DART AEROSPACE LTD	Work Order:	94397
Description: Crosstube Assembly (205/212 High Aft)	Part Number:	D212-664-241
Inspection Dwg: D212-664-241 Rev: D		Page 1 of 2

DRAWING NO. D212-664-241	TITLE CROSSTUBE ASSY (205/212 HI AFT)	REV. D	DART AEROSPACE LTD ENGINEERING ORDER		D.E.O. NO. D212-664-241-D-1	SHEET NO. SHEET 1 OF 2	SCALE NTS
DRAWN	CHECKED	MFG. APPR.	APPROVED	DE APPR.			
DATE 11.04.07	DATE 11.04.11	DATE 11.04.12	DATE 11/04/12	DATE 11.04.12

ADD AN INSPECTION WINDOW TO UNDERSIDE OF CROSSTUBE.

REPLACE MAGNOBOND WITH PROSEAL.

**D212-664-241/-241B
ASSEMBLY DETAIL**

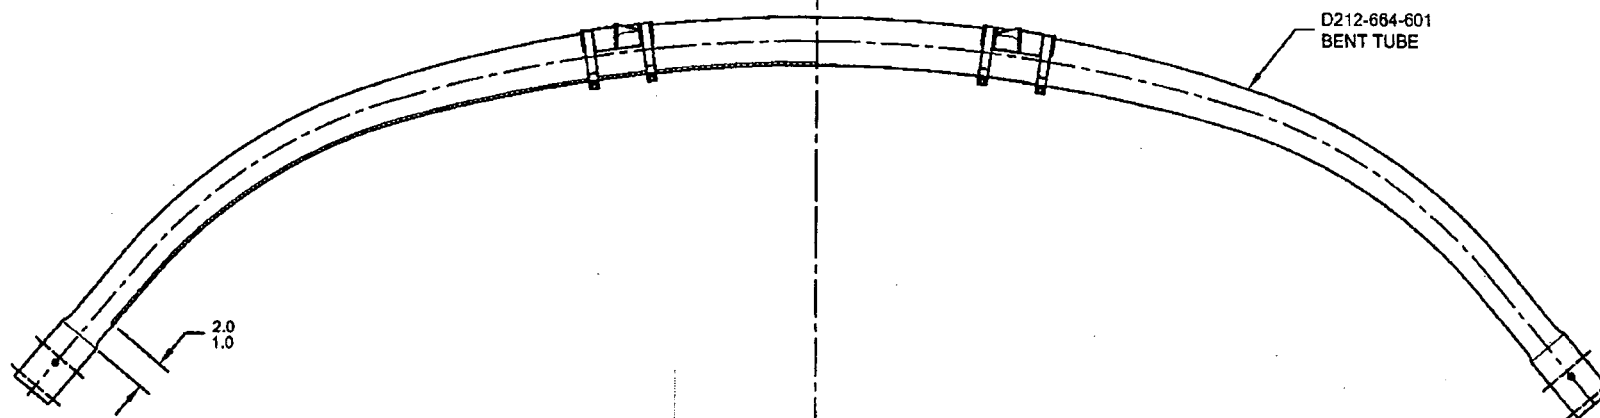
NOTES 2 OF SHEET 1 IS AMENDED AS FOLLOWS:

IS:

WAS:

MASK AREA PRIOR TO PAINTING,
REMOVE MASKING AFTER PAINT
AND APPLY CLEAR COAT

- 2) FINISH: CHEMICAL CONVERSION COAT PER DART QSI 005 4.1
PRIME INSIDE AND OUTSIDE PER DART QSI 005 4.2
MASK UNDERSIDE OF CROSSTUBE AS SHOWN (HATCHED AREA) AND
PAINT OUTSIDE PER DART QSI 005 4.2
REMOVE MASKING AND APPLY CLEAR COAT
